**COUNTERPOINT ENGINEERING INC.
SHOP DRAWING REVIEW**

Project Name DENISON CHILD CARE CENTRE NEW RETAINING WALLS

Title RETAINING WALL PLAN AND SECTIONS

Title RETAINING WALL LAYOUTS

PROPOSED RETAINING WALL PLAN SCALE: 1:200

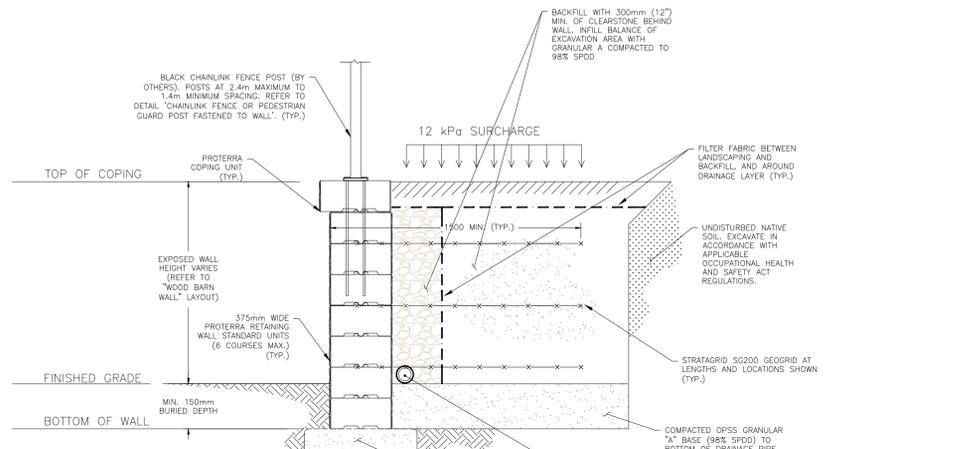
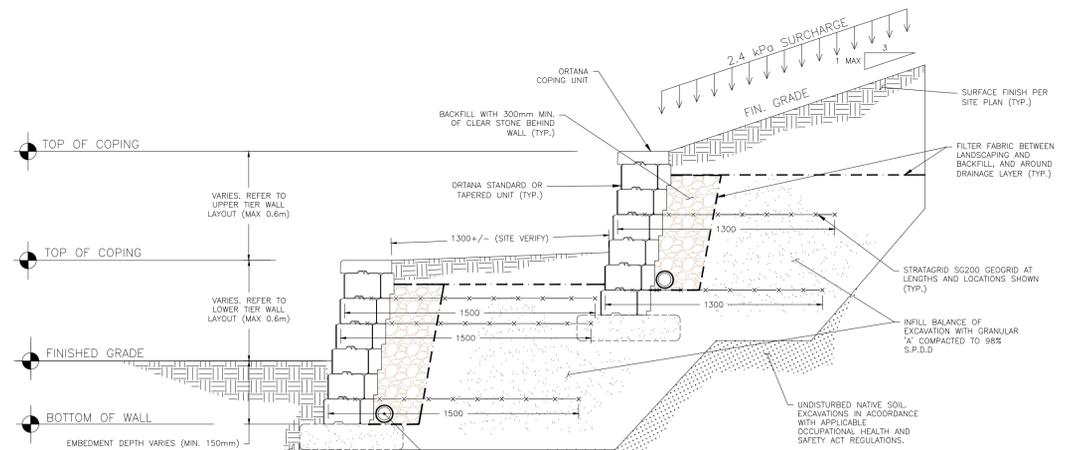
- REVIEWED (including that grading)
- REVIEWED AS MODIFIED
- REVISE AND RESUBMIT
- NOT REVIEWED

DATE: 2020-12-13 BY: CHARLOTTE BUSH, P.Eng

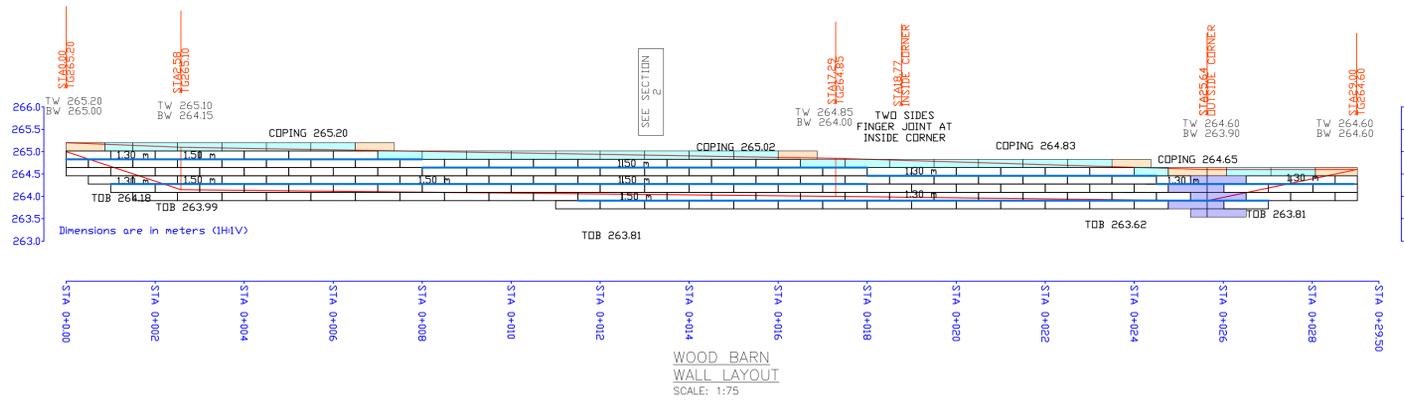
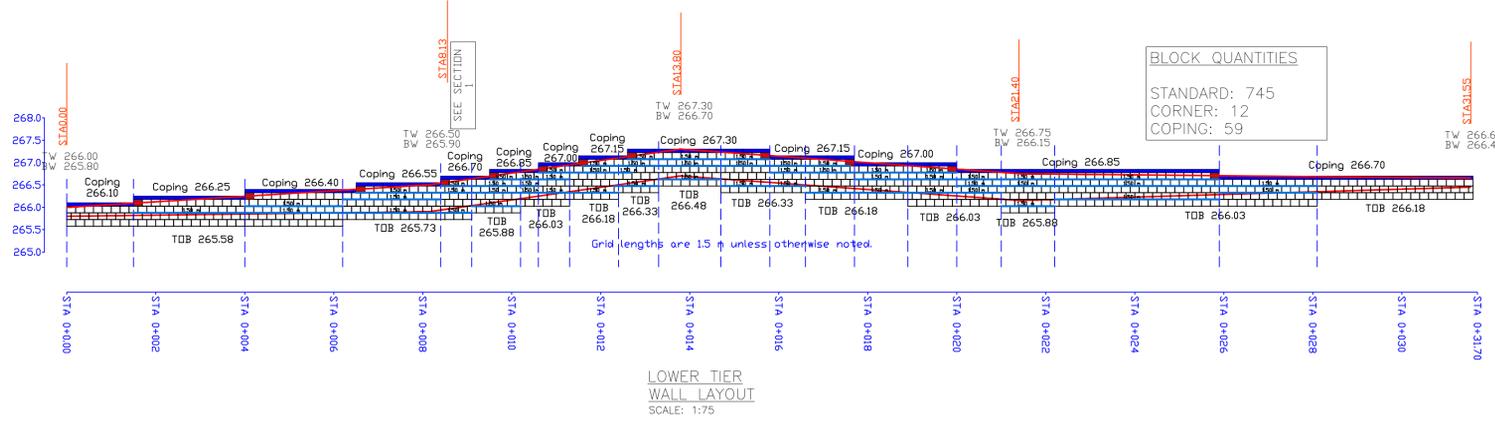
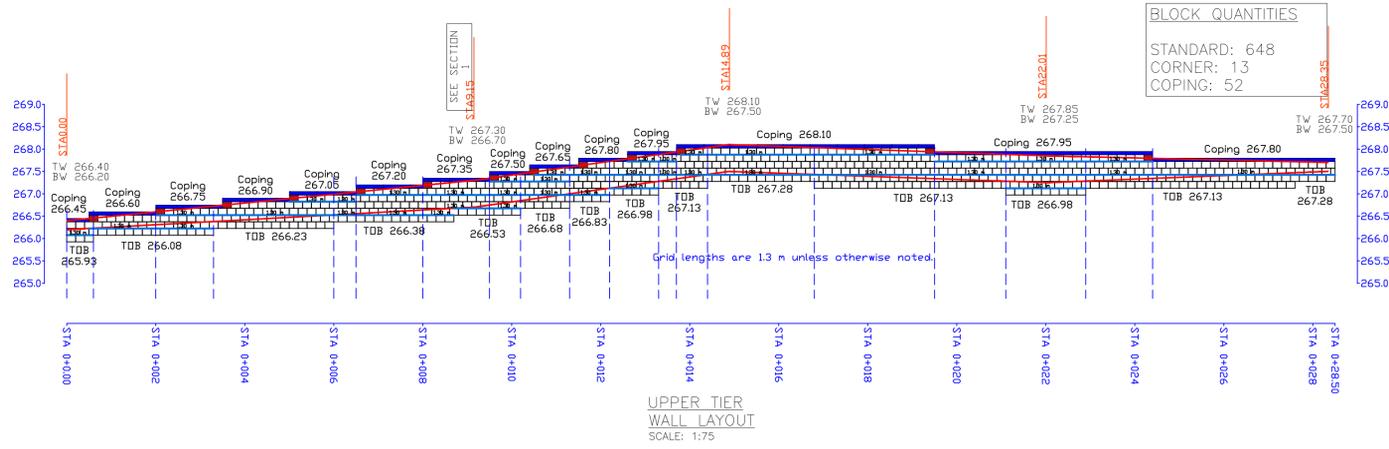
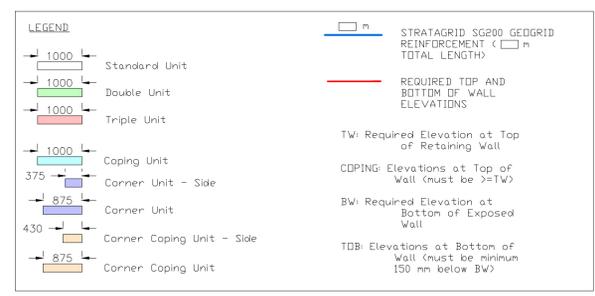
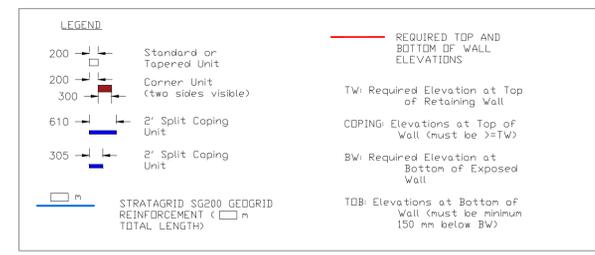
(including that grading)
 REVIEWED conforms with drawing C1
 REVIEWED AS MODIFIED
 REVISE AND RESUBMIT
 NOT REVIEWED

DATE: 2020-12-13 BY: CHARLOTTE BUSH, P.Eng.
